**APPLICATION FOR PERMISSION
UNDER SECTION 16 OF
THE TOWN PLANNING ORDINANCE
(CAP. 131)**

For Official Use Only 請勿填寫此欄	Application No. 申請編號	A/1-L1/37
	Date Received 收到日期	2025-09-09

**Proposed House Redevelopment, Amenity Planting and
Filling of Land / Excavation of Land
in “Conservation Area” Zone
Lot No. 5 in DD 7, Lamma Island**

Supporting Planning Statement

Updated Schematic Layout of Proposed House Redevelopment

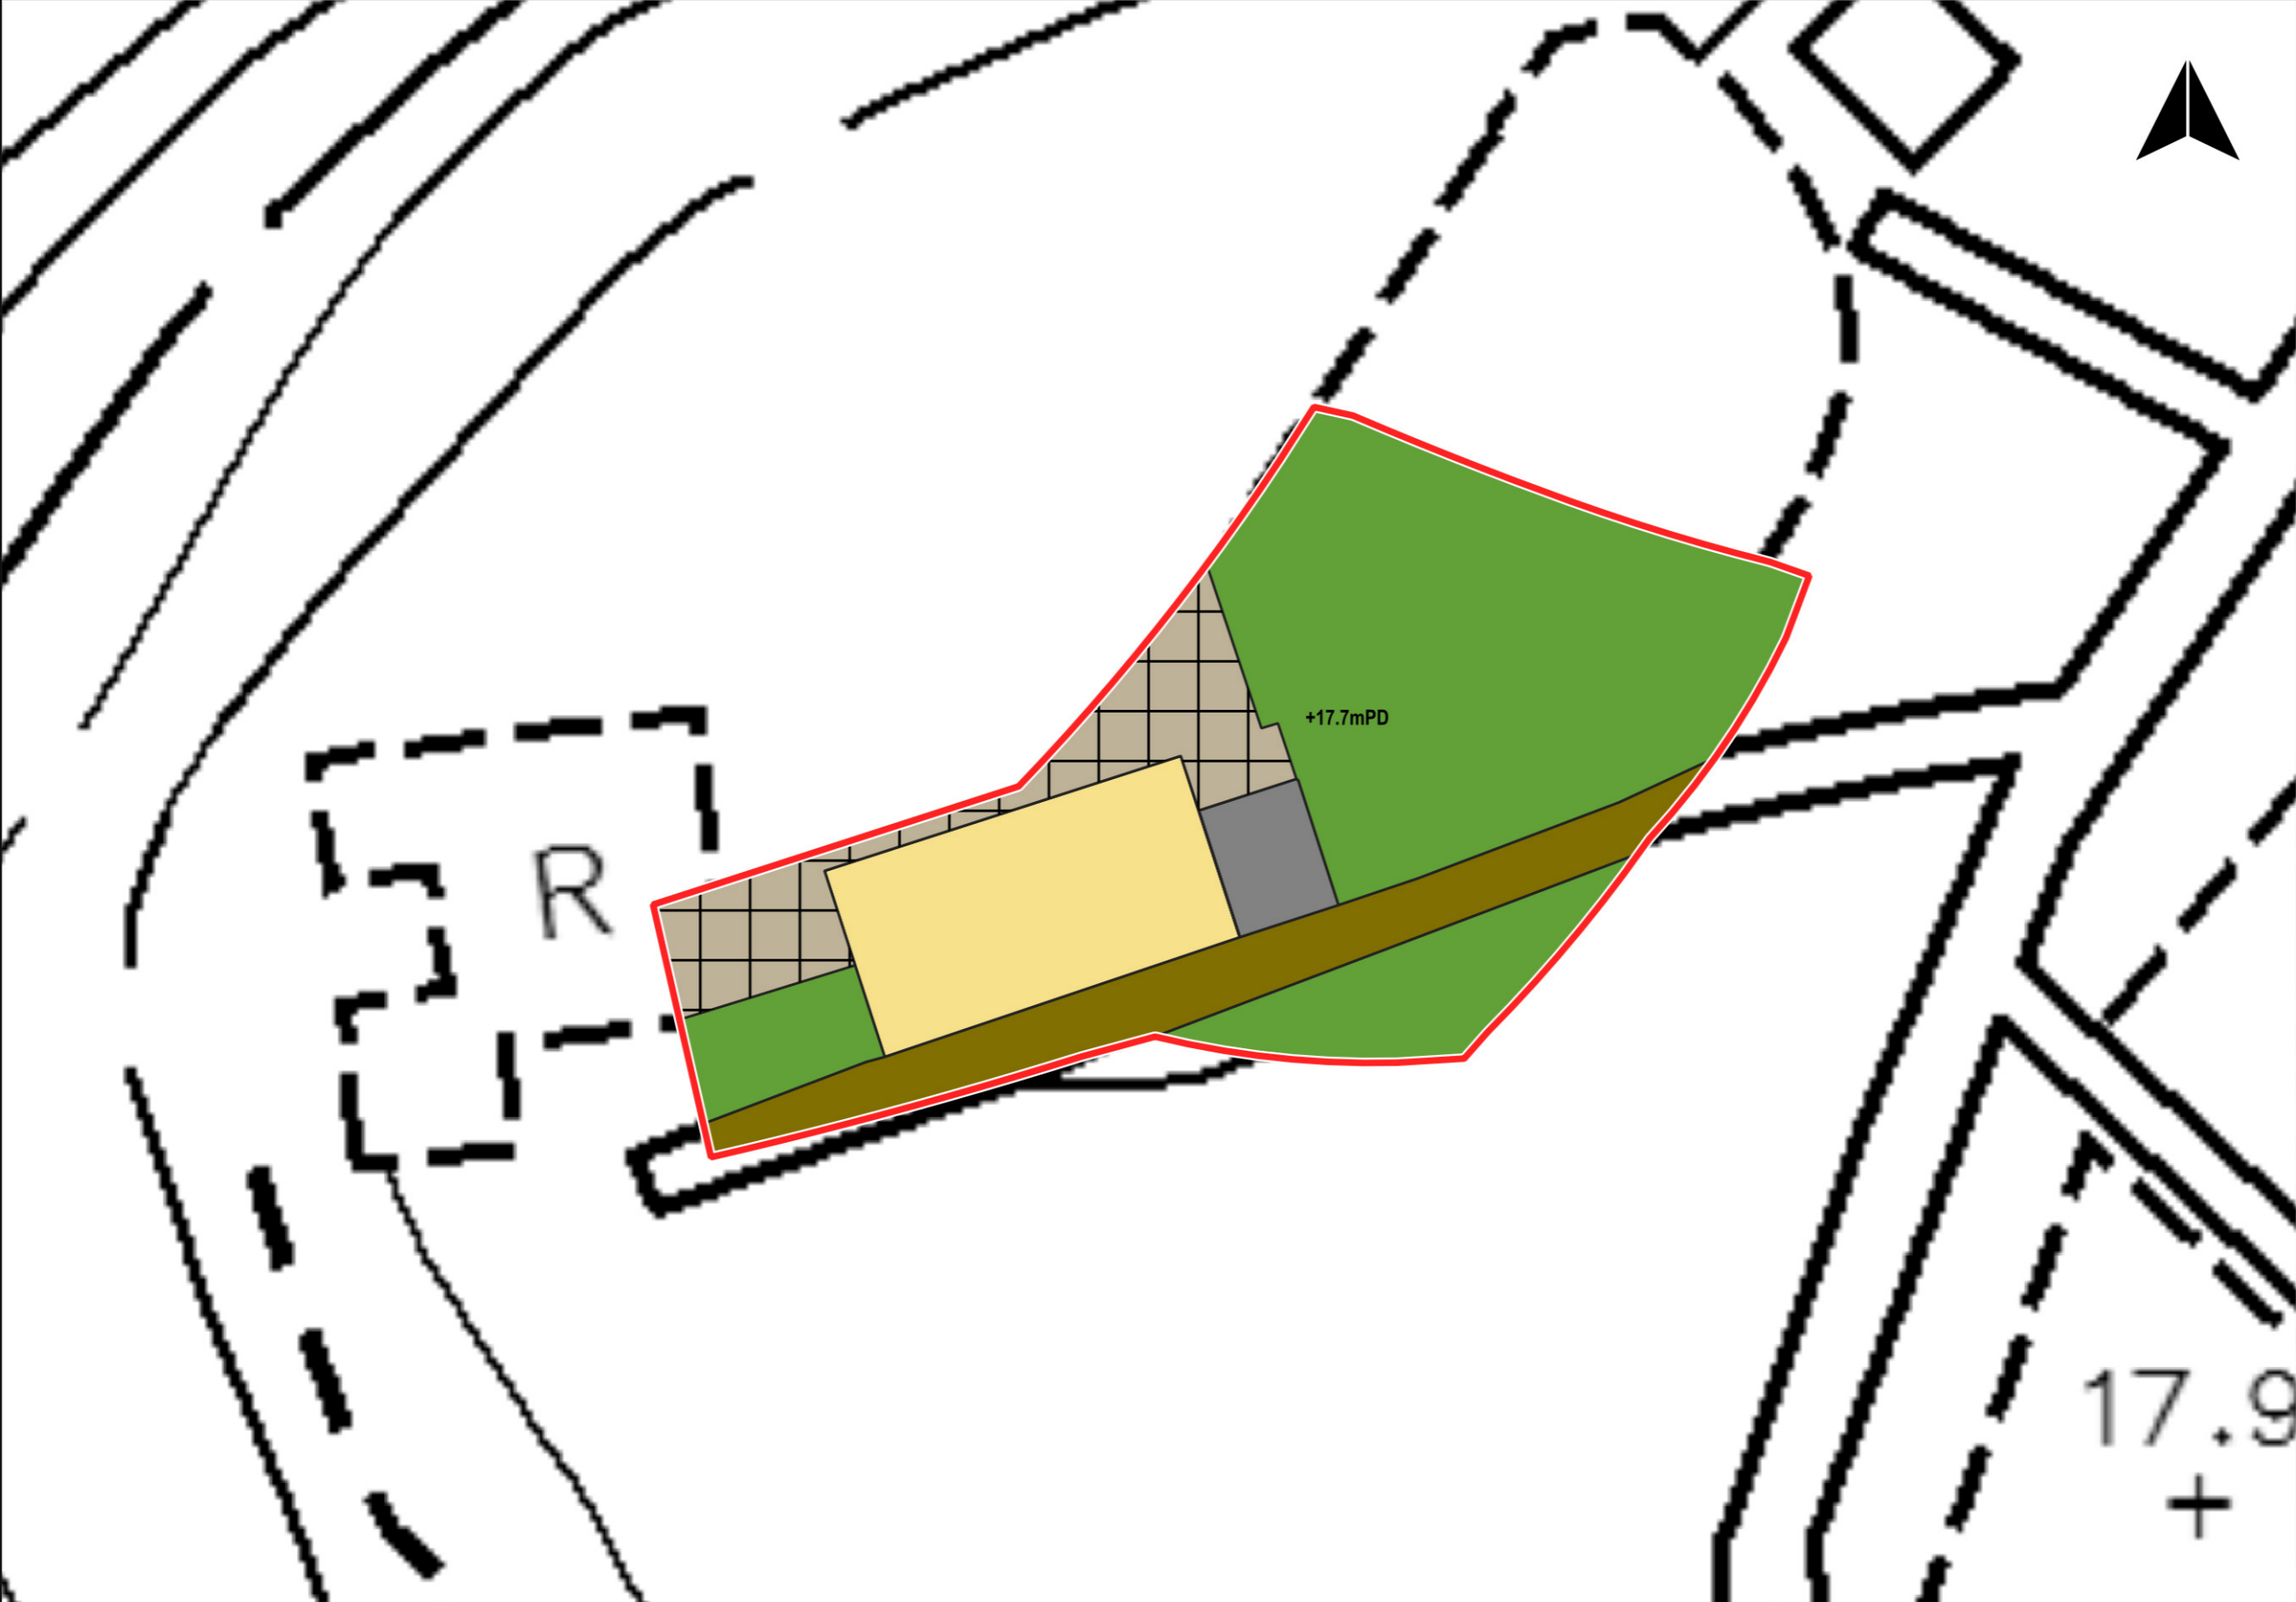
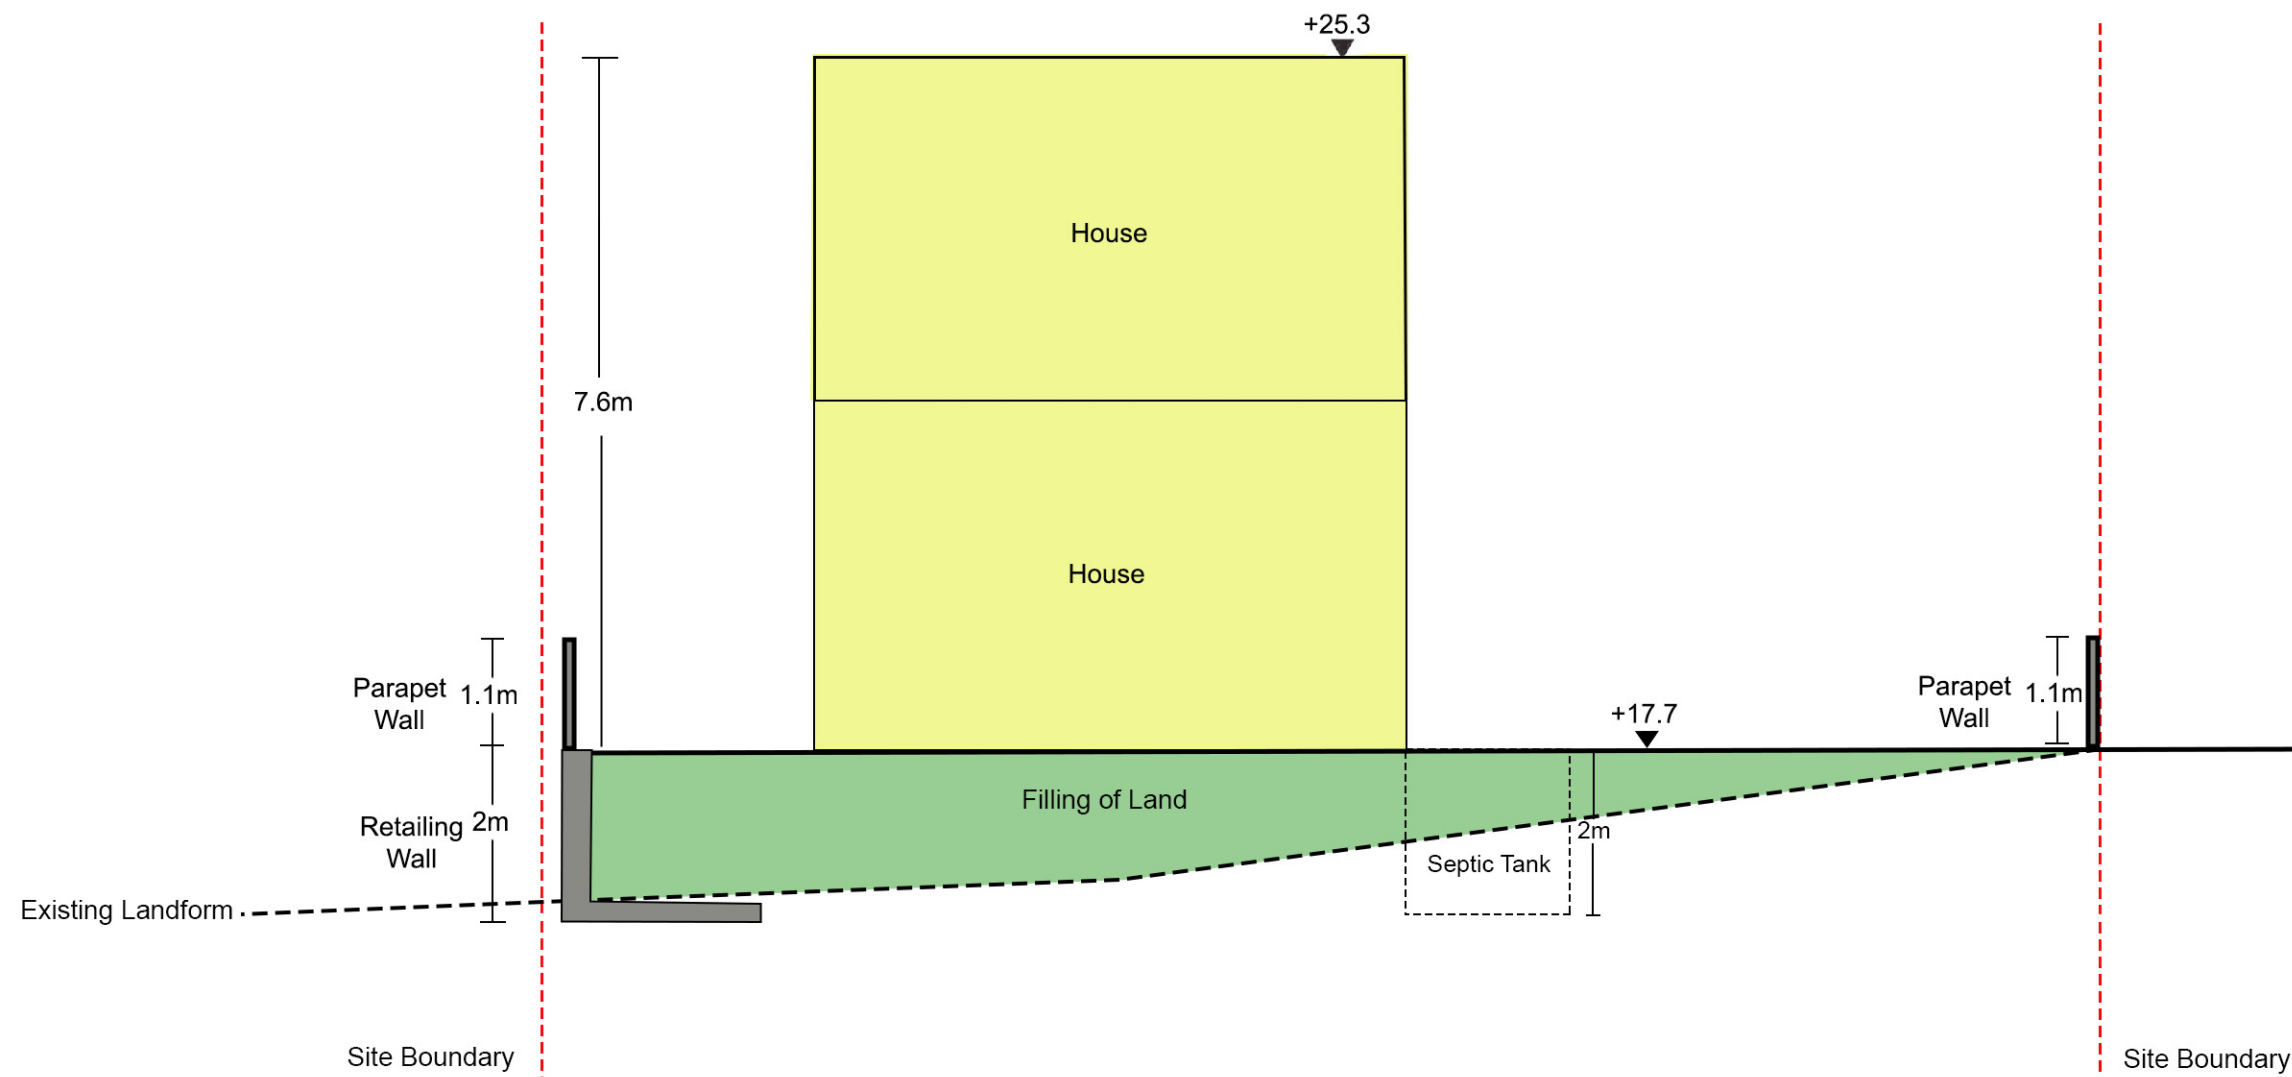
<p>Comments from Architectural Services Department (Contact Person: Ms Jacqui CHEUNG; Tel.: 2582 5322)</p>	
<p>1. The applicant is advised to provide photomontages of the proposal in its surrounding context from different vantage points for ArchSD's further comment on the visual impact of the development.</p>	<p>The Site is situated at a knoll to the northwest of Mo Tat Wan and the only public vantage point would be from the public pier at Mo Tat Wan. As shown in attached Figure 1, the proposed house, with its small scale, will be totally concealed behind the lush greenery in the foreground. Hence, no visual impact is anticipated.</p>
<p>Comments from UD&L, Planning Department (Contact Person: Ms. Isabella TSUI, Tel: 3565 3951)</p>	
<p>1. As dense tree groups are observed to the immediate north of the Site, please consider further tree planting along the northern boundary of the proposed lawn area as buffer planting to enhance the screening effect.</p>	<p>Upon review, two additional trees will be planted along the northern boundary to serve as buffer planting to enhance the screening effect. The Tree Preservation and Landscape Proposal has been updated accordingly (Annex 4 refers).</p>
